PARTS & SERVICE NEWS

REF NO.	AA03150
DATE	Oct. 30, 2003

SUBJECT: MODIFICATION OF STOP LAMP RELAY

PURPOSE: To introduce modification procedure to replace the relays for the stop lamp and to improve parts

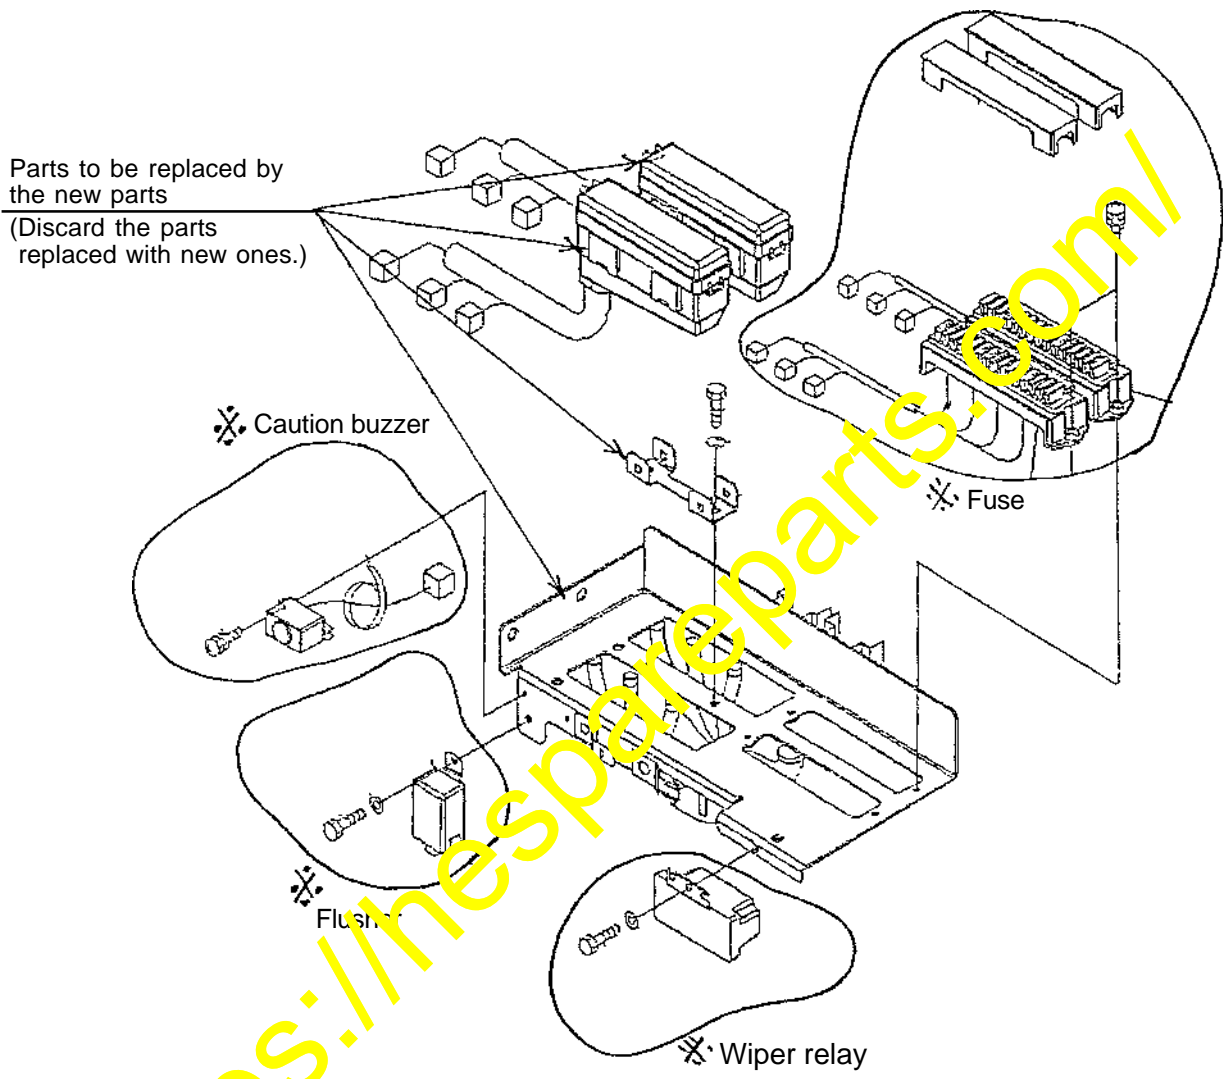
- (6) Remove the parts marked ※ indicated in the drawing below from the bracket sub-assembly which has been removed from the relay box ass'y as per Section (5) and reassemble them onto the same positions of the new bracket.
(Re-assembling parts: Fuse box 2 pcs., flusher, wiper relay and caution buzzer)

Parts marked ※ : Reusing parts

P
Detail drawing for the relay mounting section

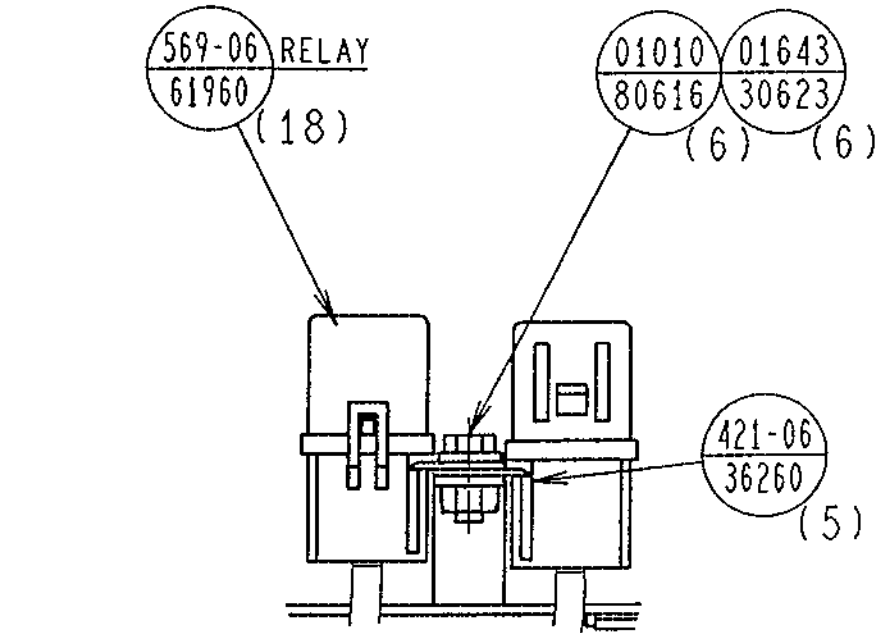
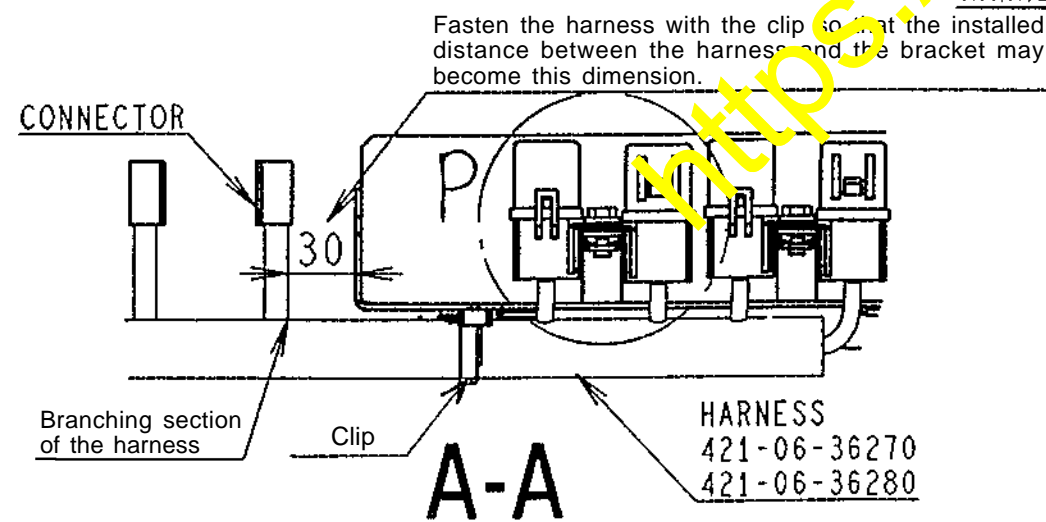
- (7) Install the improved relays and harnesses to the new bracket as per the instructions given in the drawings below.
 (These drawings are applicable to the WA380-5, WA400-5, WA470-5 and WA480-5.)

Note) For prevention of interference of the harness and bracket with the relays (CN114, CN115 and CN116), install the finisher (the two parts marked *) to the bracket in advance.

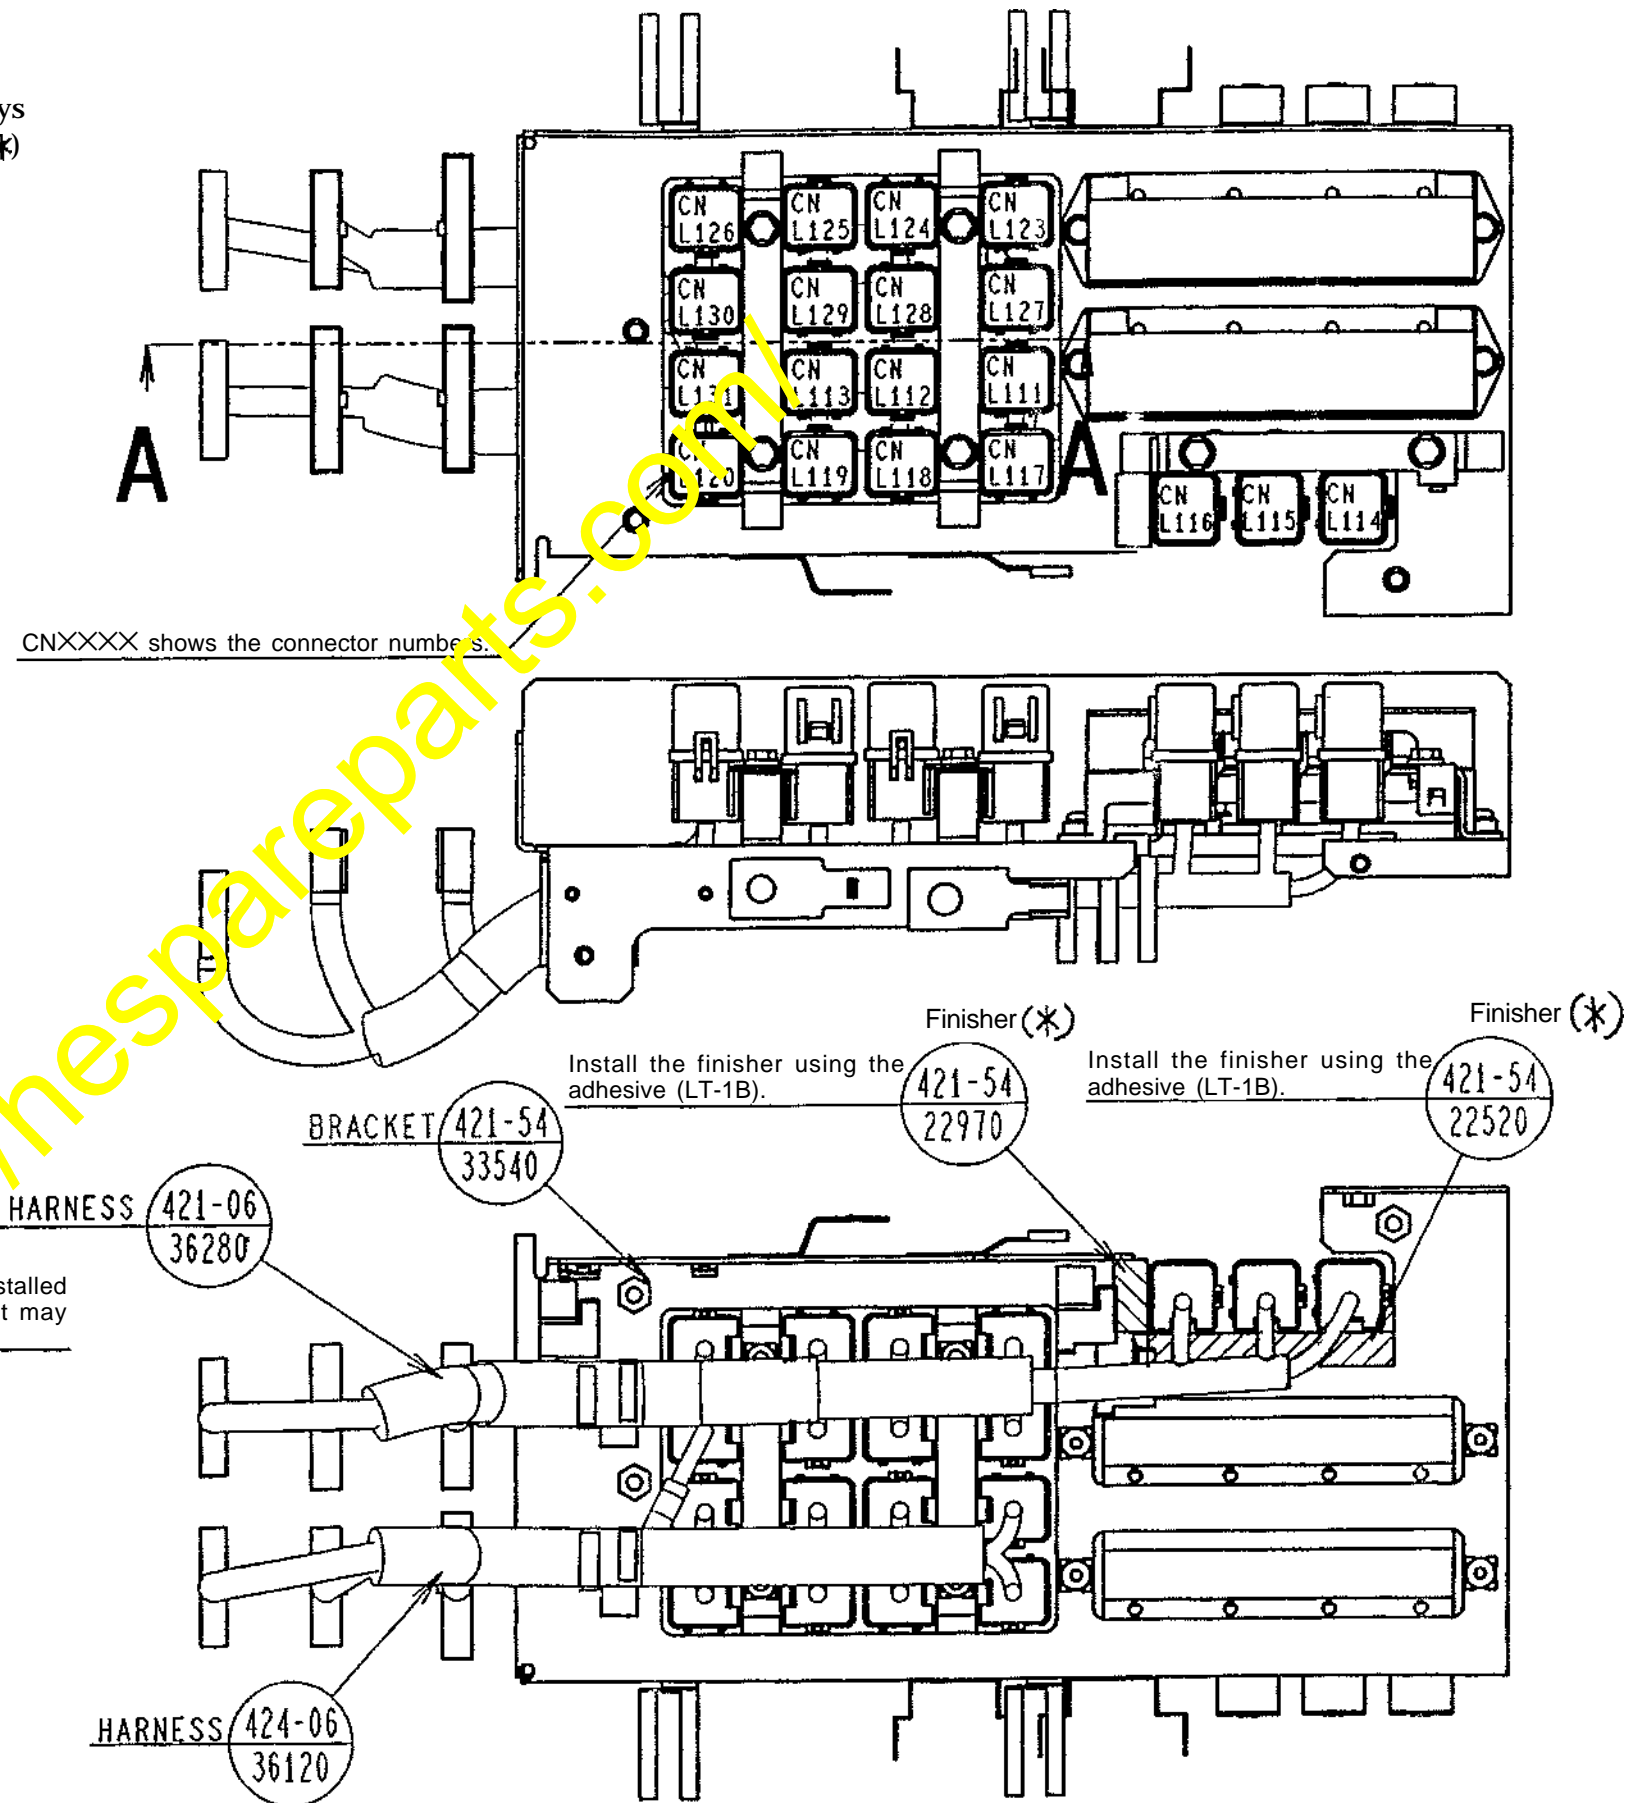
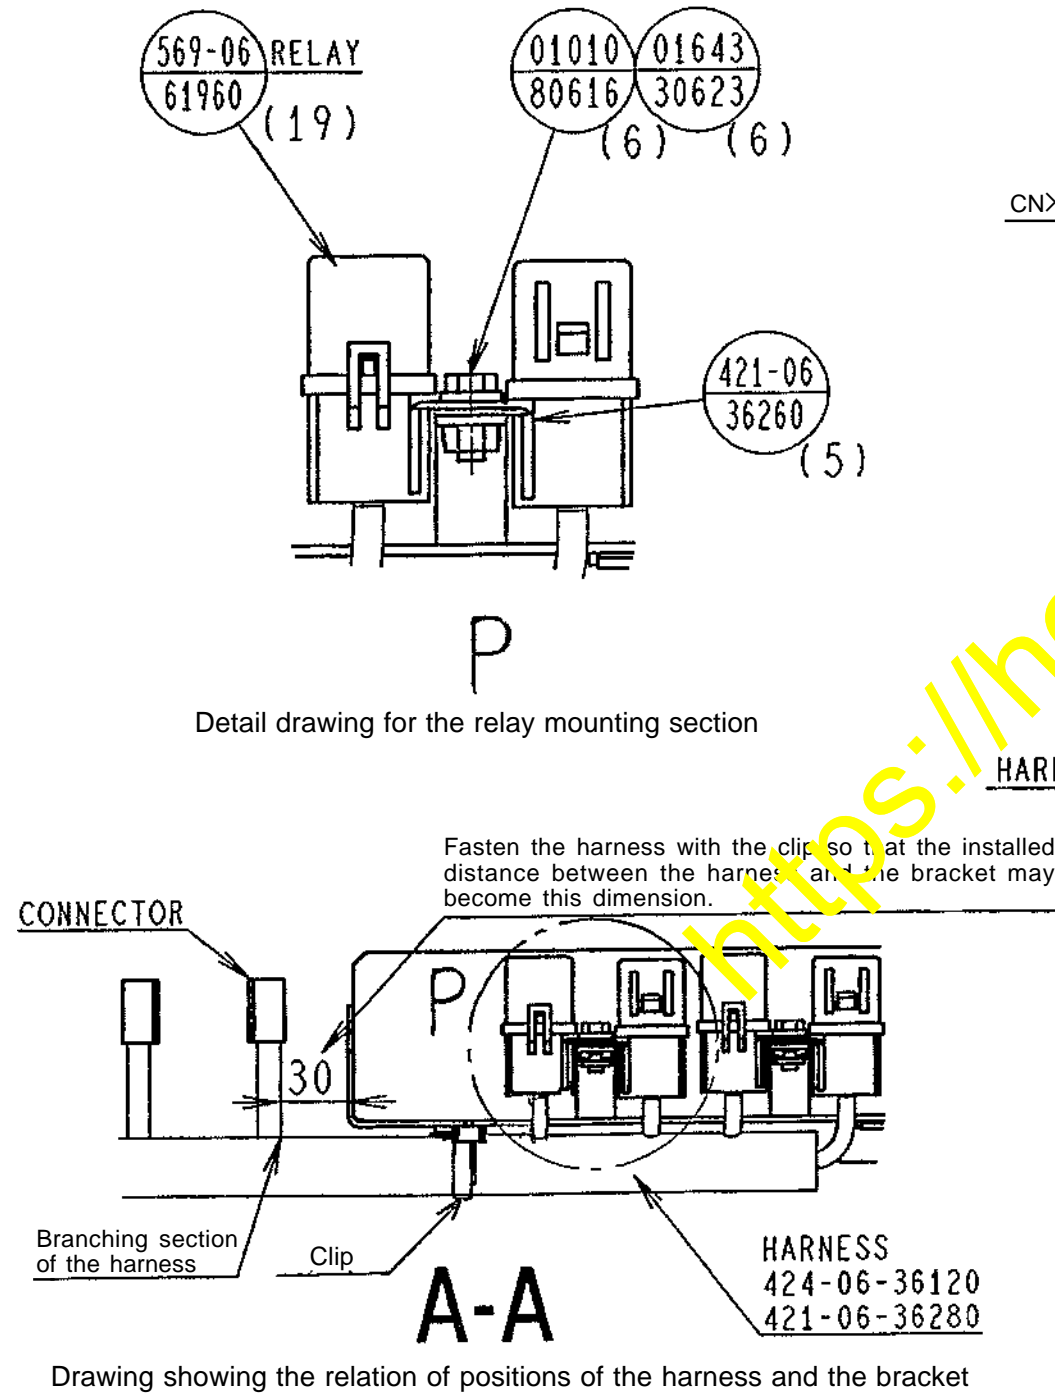
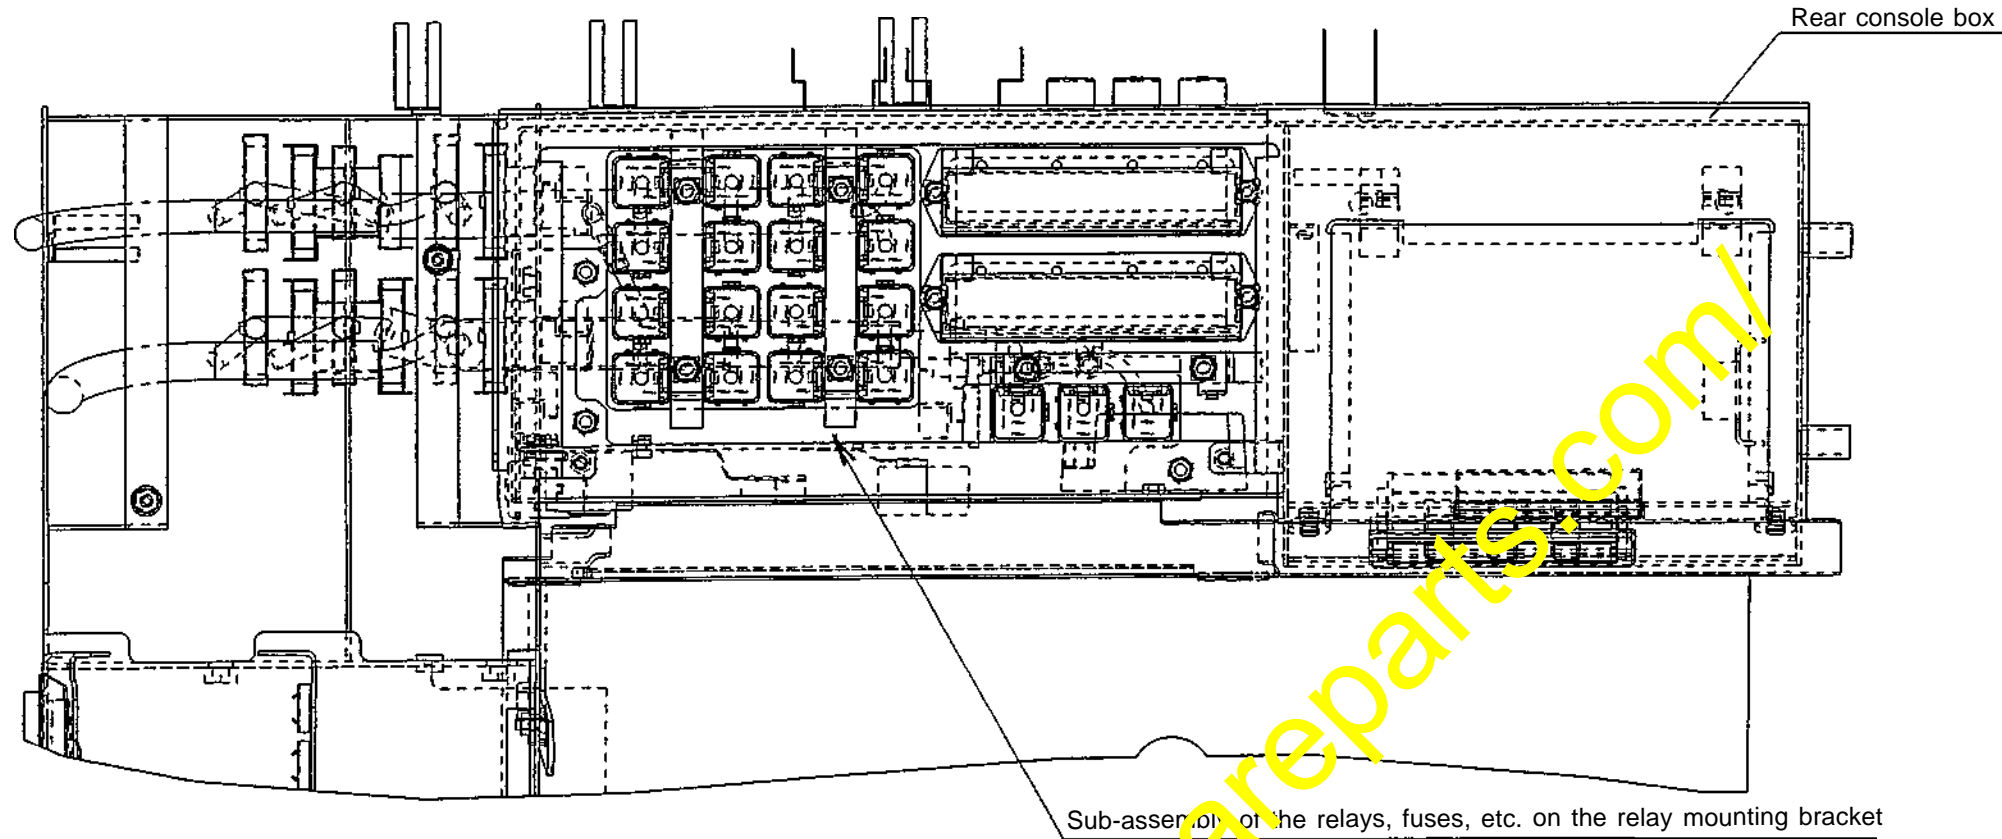
- (8) Install the improved relays and harnesses to the new bracket as per the instructions given in the drawings below.
 (These drawings are applicable to the WA430-5.)

Note) For prevention of interference of the harness and bracket with the relays (CN114, CN115 and CN116), install the finisher (the two parts marked *) to the bracket in advance.

A-A

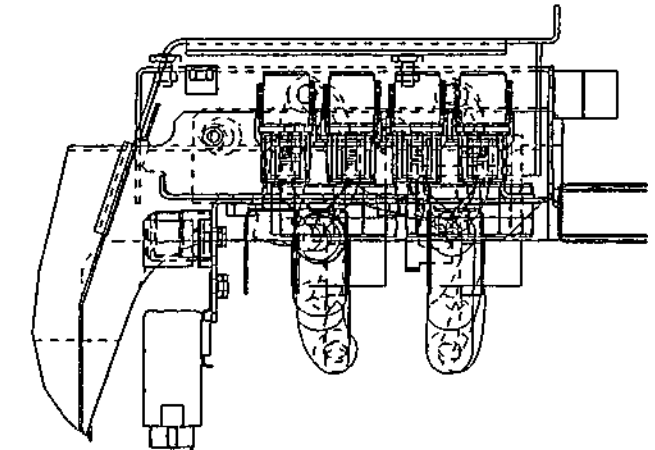
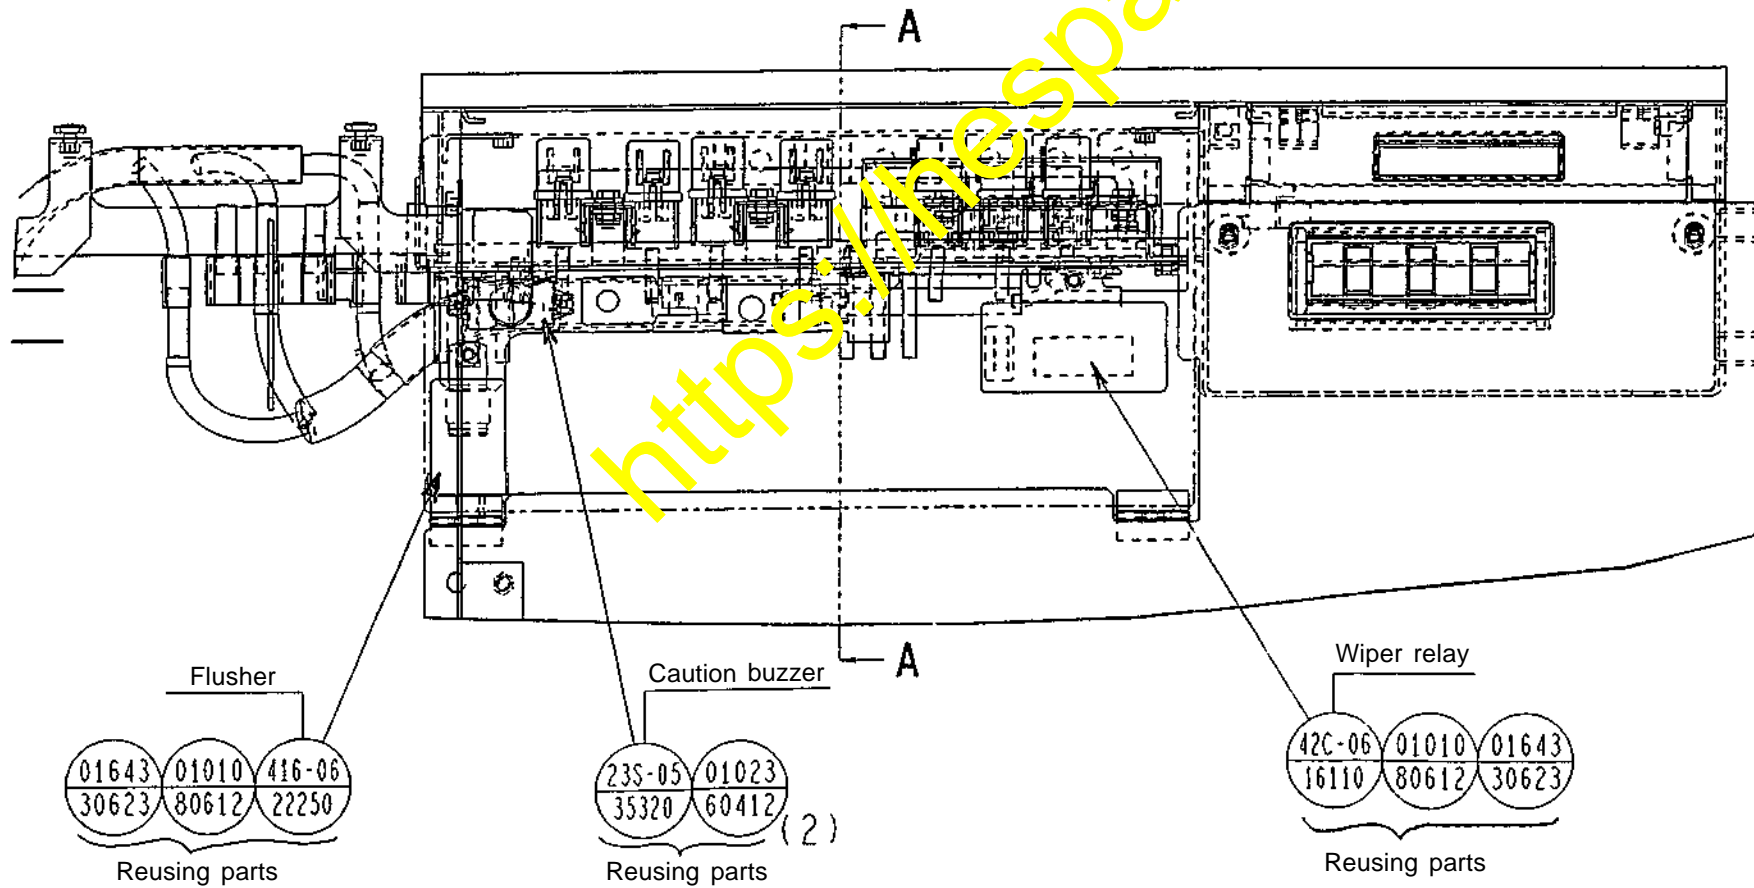
(9) Install the relay mounting bracket which has been sub-assembled per Section (8) onto the machine body for restoration.
 (This drawing is for installation on the WA430-5.)

Tightening torque when reinstalling the above bolts:

- M6 bolt : 11.8 - 14.7 Nm
(1.2 - 1.5 kgm)
- M8 bolt : 27 - 34 Nm
(2.8 - 3.5 kgm)
- M10 bolt : 69 - 74 Nm
(6 - 7.5 kgm)
- M12 bolt : 98 - 123 Nm
(10 - 12.5 kgm)
